## Stage 1 Road Safety Audit

Proposed Residential Development, Coolagad, Greystones, Co Wicklow

| <b>Document No:</b> | 211517-ORS-XX-XX-RP-TR-7d-001 |

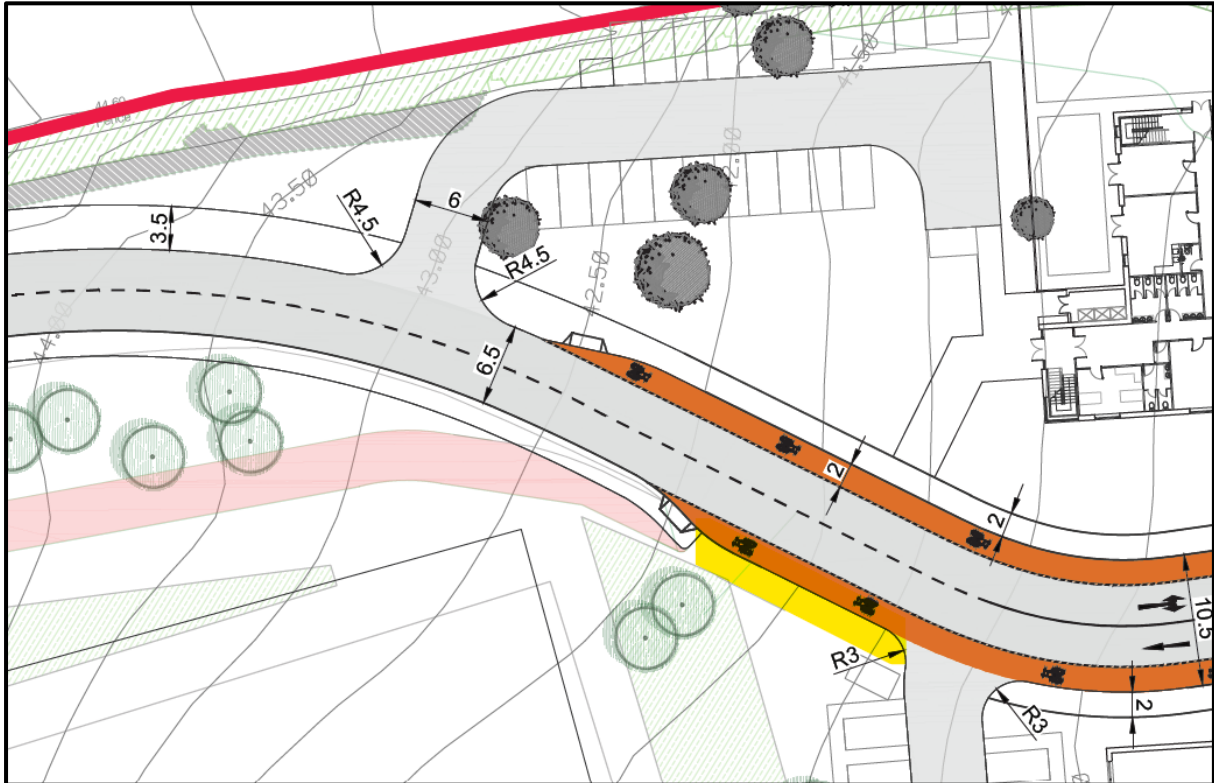
The audit team note from the proposed drawings that the distance between the major R761 junction and the community centre access junction is not specified. Minimum clearance distances as per National Design Guidelines is required for regional junctions. The audit team are concern that this could pose a risk of traffic backing up onto the main line during peak times

The design team should specify the clearance distance between the main junction and minor community centre access junction to demonstrate compliance with applicable guidelines and to ensure that the close proximity of this access to the R761 will not result in traffic building up onto the mainline during peak periods.

Opposed turning movements to/from the access for the Community Facility are the left turn in and a right turn out. If there is any queuing for the right turn, then this will not impact on the R761. If there is queuing on the right turn out of the Community Facility, then this is held within the access road and does not affect the R761. The left turn into the site is not opposed and therefore as an appropriate provision of parking for the Community Facility is provided, it may be assumed that traffic will not back up onto the road network towards the R761. Also, as the community facility is proposed for the residential facility of the SDH, the majority of trips would be assumed to originate from the residents of this new community, and therefore the majority of trips would be travelling westbound to and from the new residential community.

The proposed junction is designed as a Stop Junction and so an increased precaution will be taken by all users. As this junction is a priority stop junction along an urban link road, the appropriate guidelines would be DMURS. In accordance with DMURS and the UK Manual for Streets referenced throughout DMURS, there is research carried out for the UK Manual for Streets (and referenced directly in DMURS guidance) that a reduced visibility splay at a priority junction does not carry any further risk of injury or collisions. Further to this, it has been suggested that a reduced Y distance visibility splay may cause drivers to act with more caution. As this community centre is not envisioned to have excessively high daily traffic departing from the minor arm of this junction, a reduced visibility splay may be provided, as there is not a great deal of associated traffic from the minor arm to the major arm of this junction. The visibility splay can be drawn to the opposite kerb line on the Regional road as it shows the driver can see the full extent of the junction and therefore meets the 49m required.

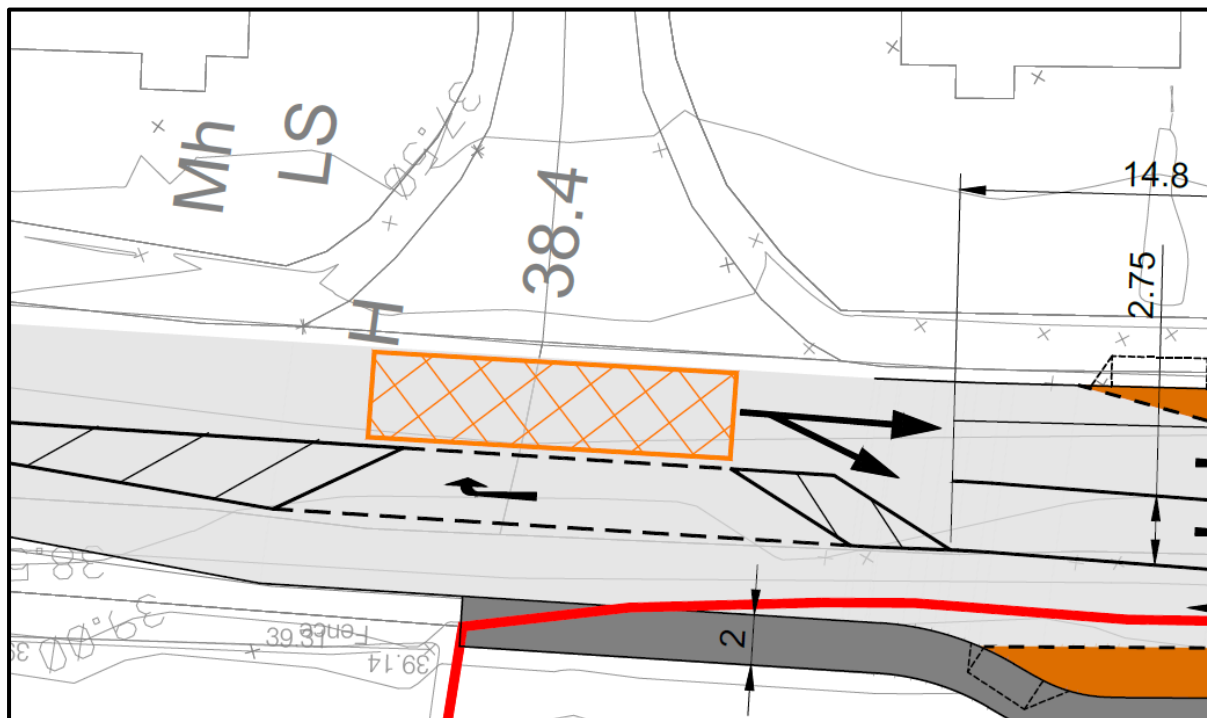
The audit team note from the drawings provided that proposed pedestrian paths are shown to terminate to the north and south of the cemetery entrance with no drop kerb and tactile paving. Insufficient pedestrian permeability may put vulnerable users at risk. Inadequate disabled facilities may result in slips trips or falls resulting in injury.

The design team should review the existing footpath layout to ensure continuity of all surrounding paths within the scheme boundary in line with DMURS guidelines.

Please note that the footpaths north and south of the cemetery are not proposed, the existing footpaths are proposed to remain as is. The existing footpaths are asphalt pavements that ramp down to the area fronting the cemetery entrance. See below.

This area is outside the remit of our scheme, and if brought up by WCC for improvement, it could be considered to be further addressed at detailed design stages.

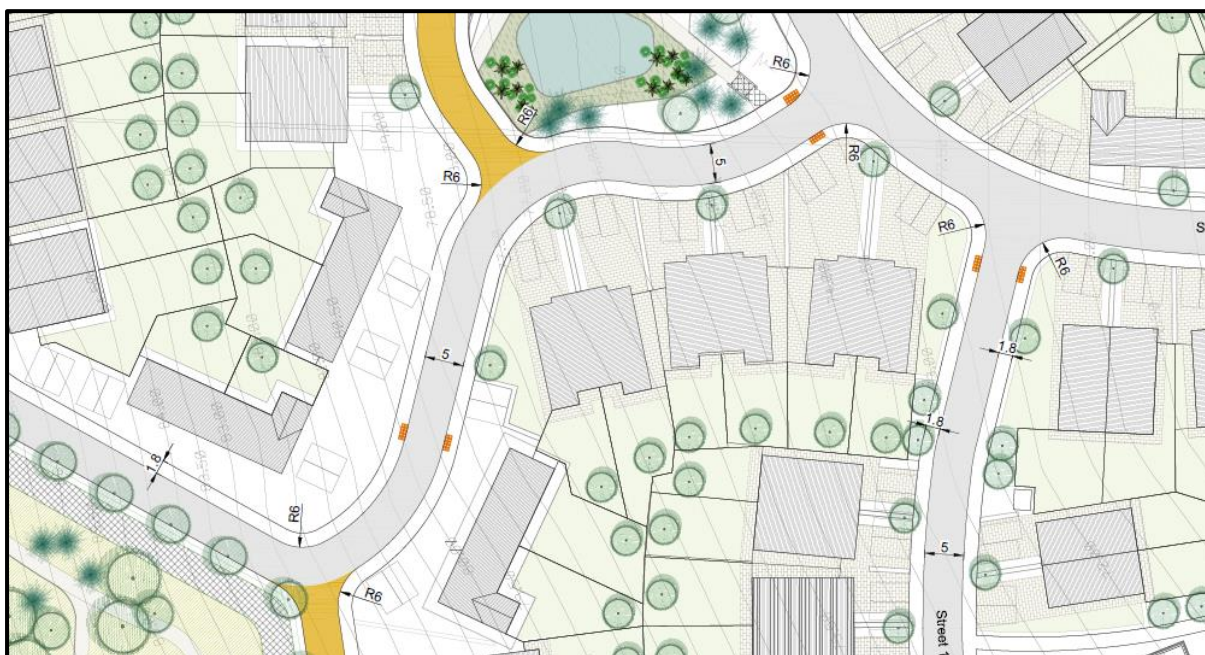
The audit team note that 'drop kerbs' and tactile paving are not identified throughout the scheme. These facilities aid users with specific mobility needs in particular and the omission of dropped kerbs will require vulnerable road users to travel in the roadway to find a suitable location to mount the footpath putting them at risk of conflicts with vehicles.

The design team should ensure that details and locations of 'drop kerbs' and tactile paving is provided throughout the scheme at proposed crossing points

This is outside the remit of our scheme, and if brought up by WCC for improvement, it could be considered to be further addressed at detailed design stages.

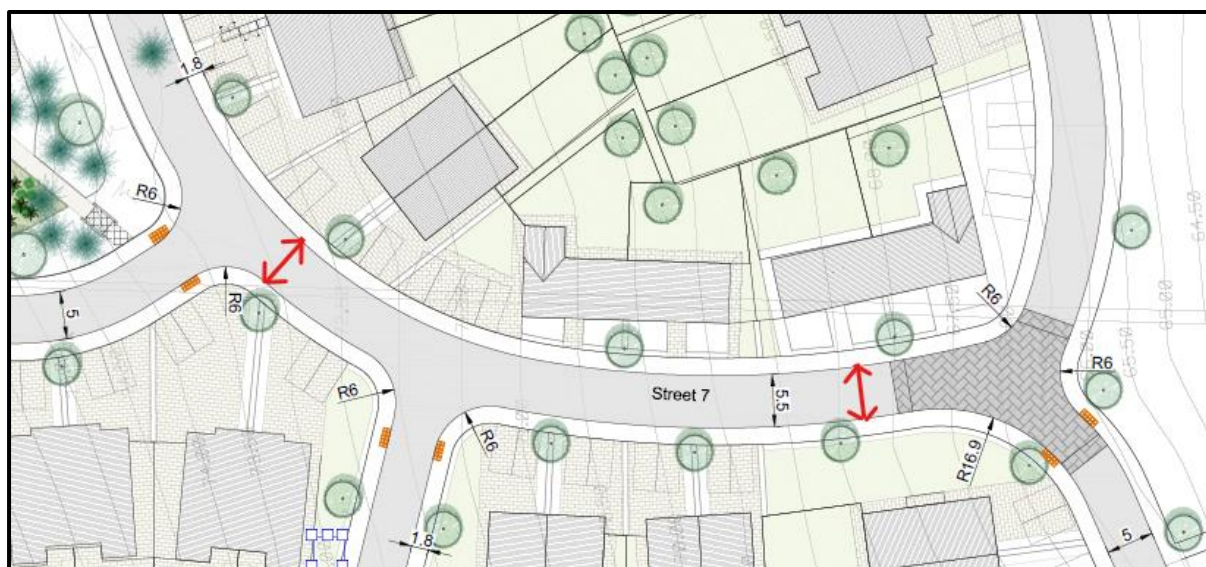
The audit team note from the drawings provided that the signalling phasing diagram is not available for review. Incorrect phasing may result in vehicle/pedestrian or vehicle/vehicle conflicts resulting in injury.

The design team should include the phasing diagram for review at detailed design stage.

Please find attached the phasing diagram.

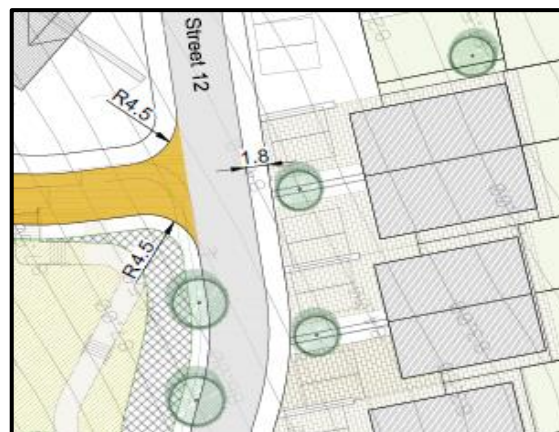
The audit team have not received drawings detailing lighting for the development and the access junction and it is not clear if lighting will be specified for the development. Areas in low light conditions may result in slips trips and falls on pedestrian paths. Drivers may be unable to see pedestrians in the internal road network and at pedestrian crossings which has the potential to lead to pedestrian-vehicle collisions resulting in injury to pedestrians.

The design team should ensure that details and locations of all public lighting columns are provided for at detailed design and to ensure that positioning of columns does not cause any obstruction or hazard to vulnerable users.

The details and locations of all public lighting columns will be provided for at the detailed design stage.

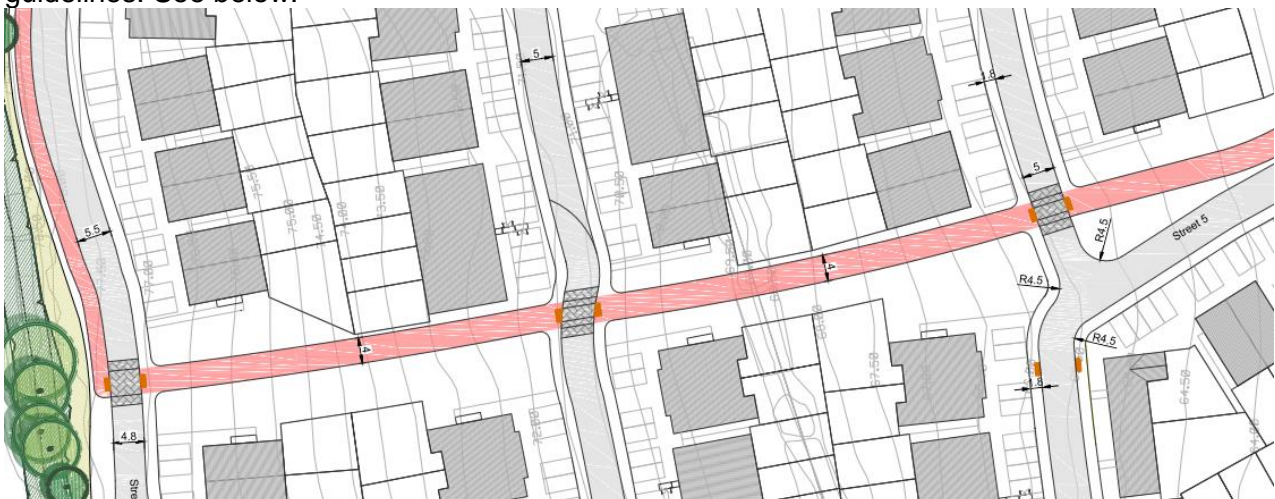
The junction is very wide and has no pedestrian crossing facilities and could be redesigned to provide drop kerbs, tactile and improved radii on corners, but we don't believe it is within the client's remit to upgrade this existing junction.
